### Required Modifications (Oct 13, 2015 Koji Arai, Oct 29, 2015 Daniel Sigg)

Circuit schematic D0900848-B: W2

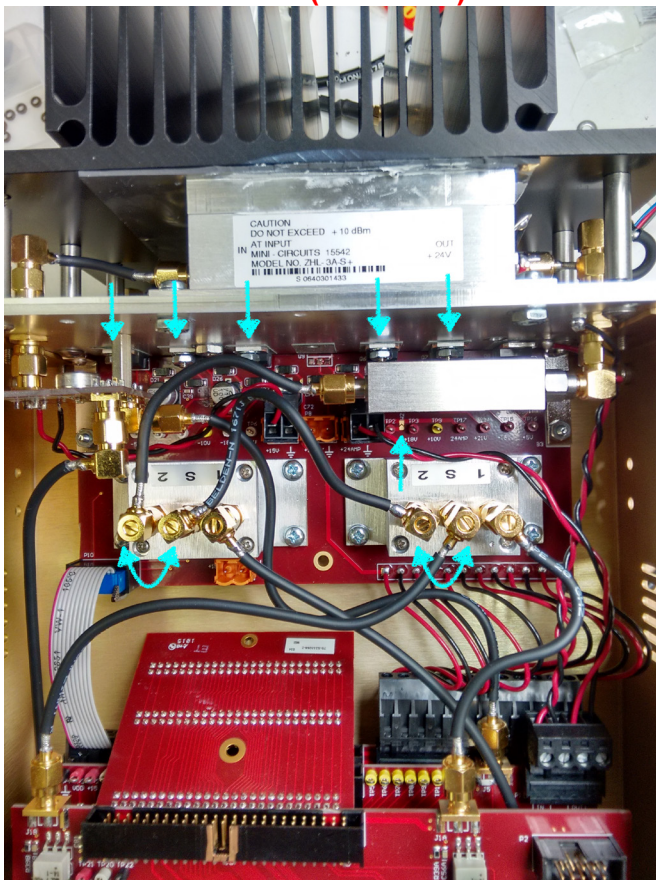
2. The W2 jumper needs to be connected with a solder ball.
